CHANGE ORDER NO 4 (#2011.216)

PROJECT: Lake Village Ph II Water Quality Improvement Project- EIP Project #679
PWP-DO-2010-262

Attachments: Copy of portions of sheet #C8, tabulation of line items involved in the work.

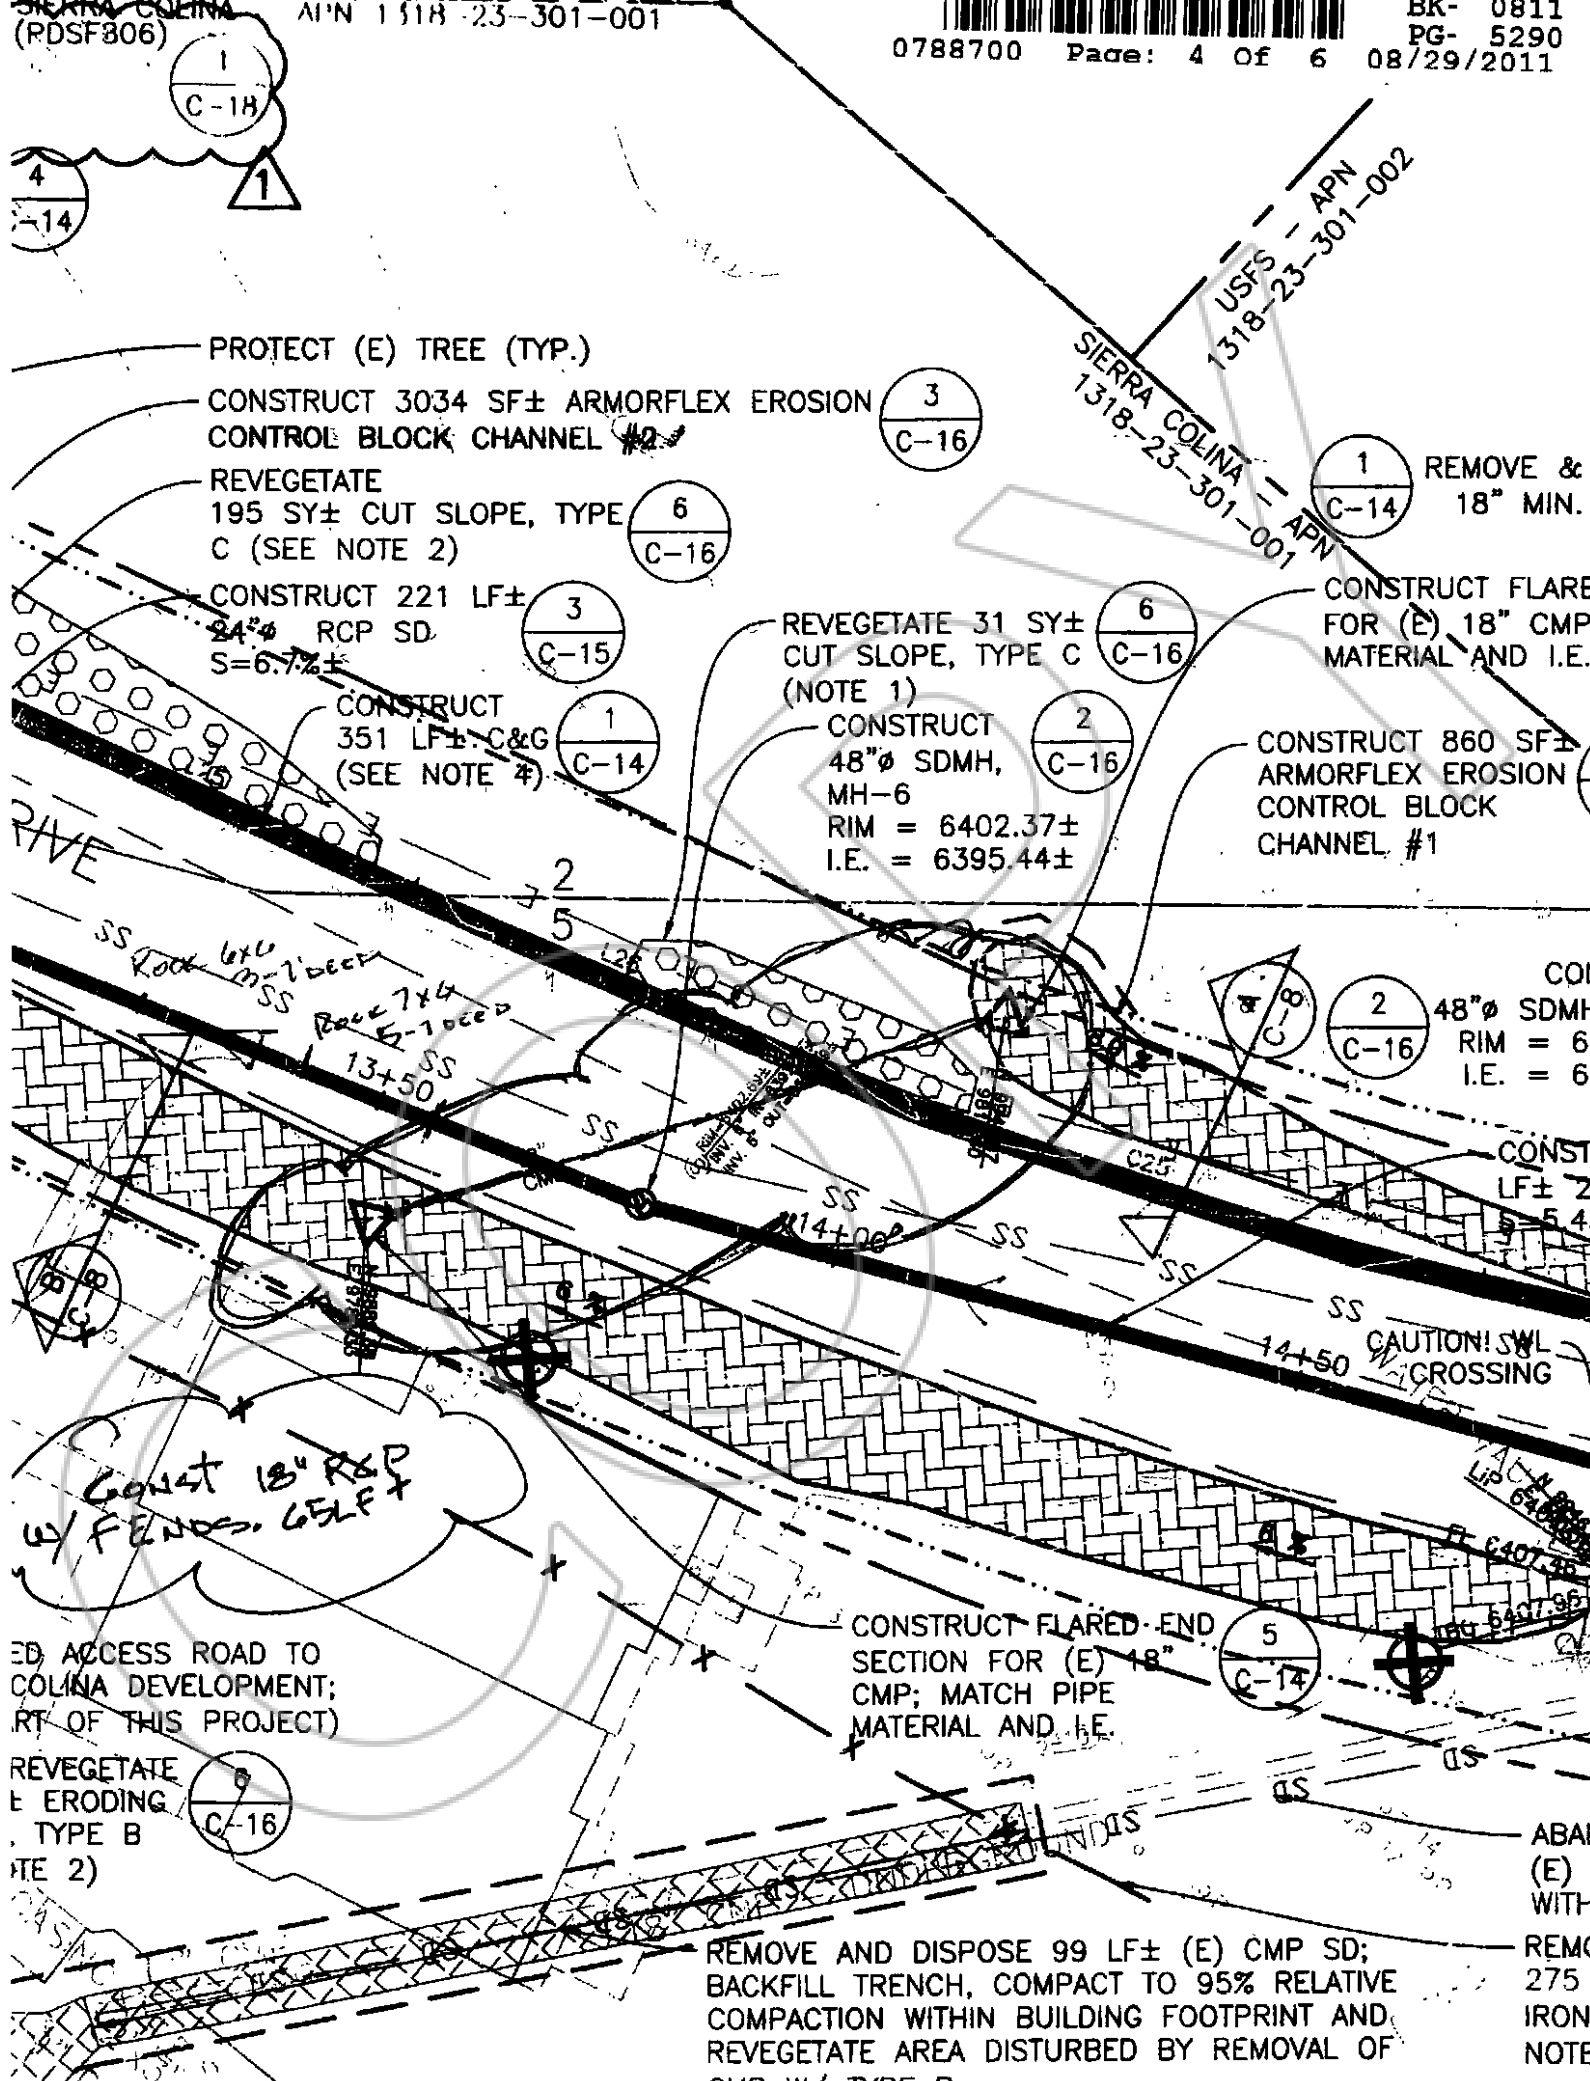
Description: 1. remove & replace the 18" CMP at sta+/-13+75 with 18" RCP; do not video the existing pipe.

Do Not VIDEO; R & R w/ 18" RCP

CAUTION! 18" CMP STORM DRAIN
CROSSING; PROTECT IN PLACE; VIDEO
SURVEY PIPE AND SUBMIT VIDEO TO
OWNER; REMOVE AND REPLACE IF
NECESSARY (ALTERNATE BID ITEM)
